Plantation Productions, Inc.

TITLE: Ethernet_DOUT.MT

Design by: **Randall Hyde** REV:

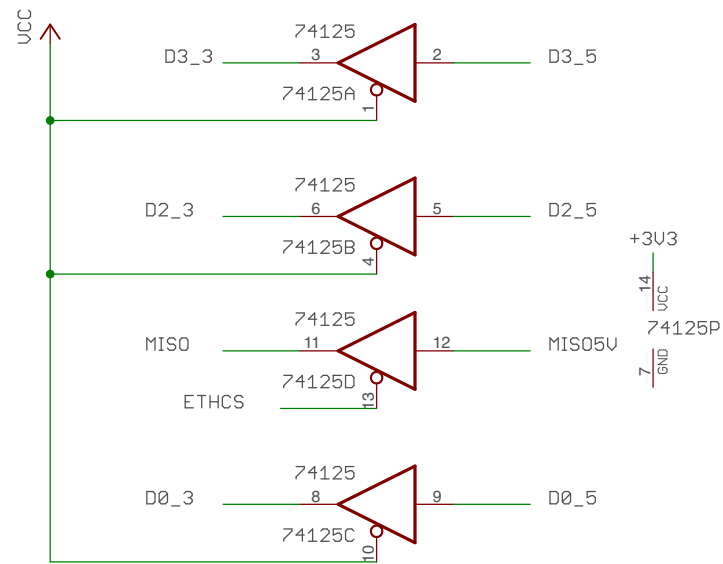
Rev 2:
 Connected 3V3 (pin 26) to Feather 3.3V.
 Added 741vc125 buffer to protect MISO line.
 Redesigned serial shift register logic to use 74HC595 ICs.
 Changed LED resistor to 470Ω.

Rev 3:
 Connected Feather RST line to Teensy PROG.
 Changed serial output from QH to QH' on the 74HC595 ICs.
